City of San Antonio TRANSPORTATION AND CAPITAL IMPROVEMENTS

ADDENDUM No. 2

PROJECT NAME: INGRAM ROAD (CULEBRA ROAD TO MABE ROAD) - ID NO.:40-00307

DATE: October 22, 2014

INGRAM ROAD CULEBRA TO MABE WATER SYSTEM UTILITY ADJUSTMENTS PLAN

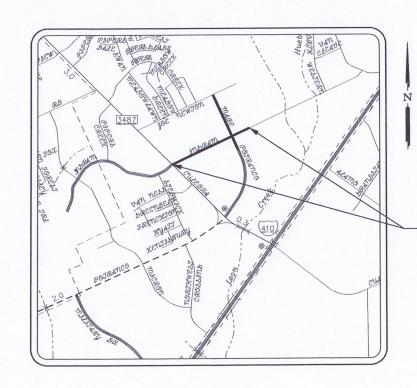
SAWS Clarification: SAWS Water cover sheet has been revised to reflect the two line items added with addendum #1: "1015 Service Line Break Leak Repairs" & "1020 Water Main Breaks Leak Repairs". See attached revised sheet.

- 1) SAWS Water Cover Sheet: Added line item 1015 & 1020 (1 sheet)
- 2) Revised 025 Form: Added line item 404 Corrugated Metal Pipe (1 sheet) (Revised Excel Sheet)
- 3) Revised General Specifications: Added spec 404 Corrugated Metal Pipe (7 pages)
- 4) Revised Reconstruction Quantity sheet No. 22: Added line item 404 CMP (1 sheet)
- 5) Revised Reconstruction Quantity sheet No. 24: Added line item 1015 & 1020 (1 sheet)
